Road Safety Audit Report

Location: Bogong High Plans Road, Falls Creek, Victoria
Issue: Proposed Change Above Windy Corner
Audit Stage: Concept Design
Client: Jonathan Spring

Report Issue Date: 12 August 2022

RSA Reference: 12931

At the bowl intersection (restricted sight distance to the south from the ski trail)

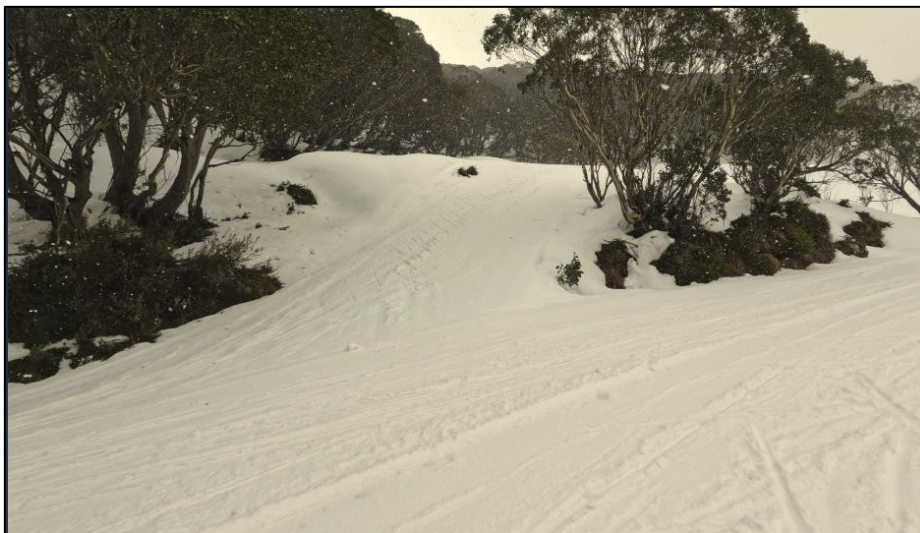
| Risk | Affected Road Users | Risk Rating (Austroads GRS Part 6) |
|--|-------------------------|--|
| Bowl intersection: skier at eastern trail struck by vehicle due to restricted sight distance to the south. | Skier | Risk Rating = Unlikely (3-7Y) + Moderate = Medium |

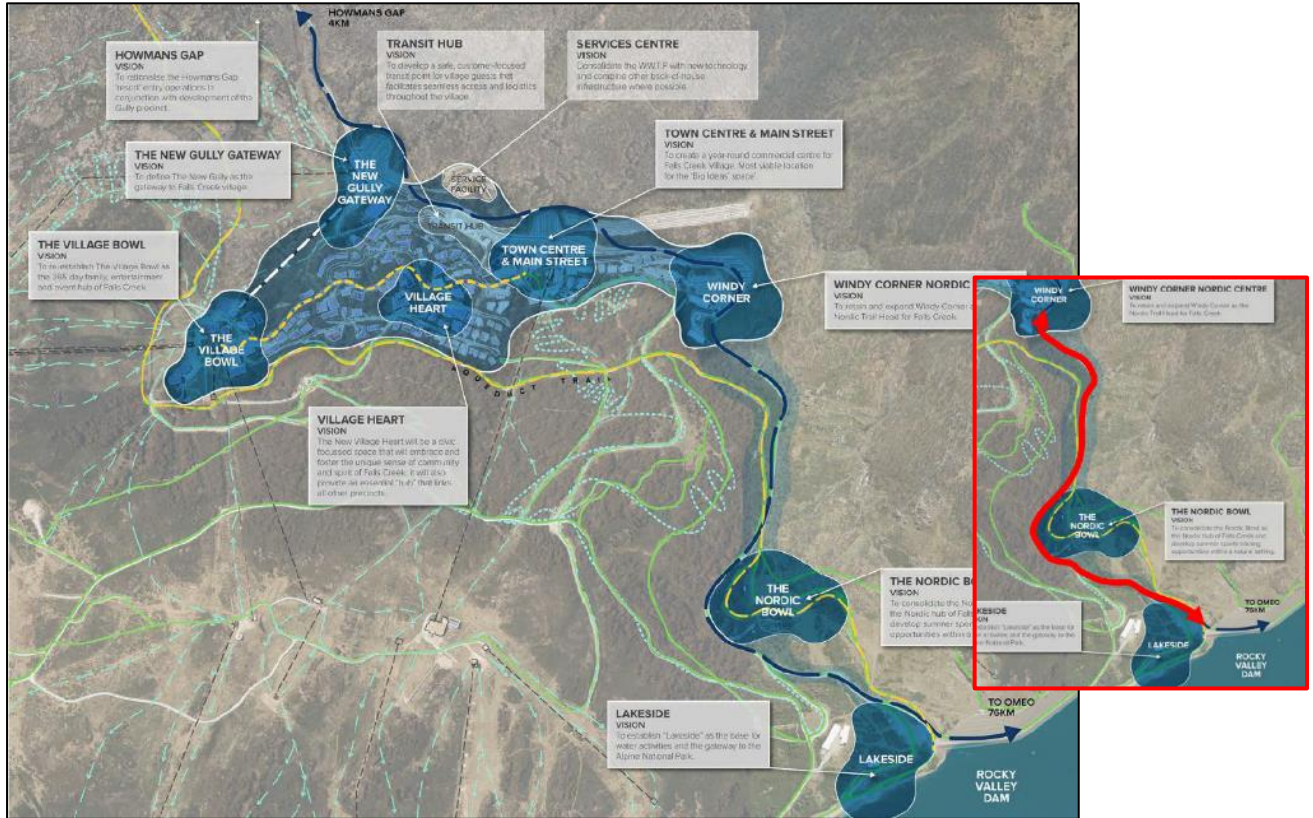
A major toboggan area is right at the commencement of the section of road proposed to be cleared of snow. i.e. it abuts Windy Corner. There appears to be conflicting publicly available information about whether this sheltered toboggan area will be moved to the exposed slopes adjacent to BHP road on the approach to the ANARE building. This audit is therefore assessing the risks of maintaining the toboggan area where it is currently situated.

There will be significantly more traffic, including heavy vehicles, travelling past this toboggan area where people, including many children, are mingling, playing and crossing the road.

| Risk | Affected Road Users | Risk Rating (Austroads GRS Part 6) |
|--|-------------------------|--|
| Pedestrians struck by vehicle at toboggan area. | Pedestrians | Risk Rating = Possible (1-3Y) + Moderate = High |

- What is the pavement condition?
- Should there be vehicle size restrictions (depending on the season)?
- If the road was to be opened / cleared of snow, should it still be closed in certain weather conditions?
- How often should de-icing salt be applied to the road to reduce ice?
- Should there be public transport along the route with stops in between and can the stops be safely accommodated?
- Should pedestrians be discouraged / prohibited from walking on the road?
- How will the major intersections be safely managed? (at the Bowl and McKay Road)
- How will other ski trail interfaces be safely managed?
- How will the interface with the toboggan area be safely managed (or will it be moved)?
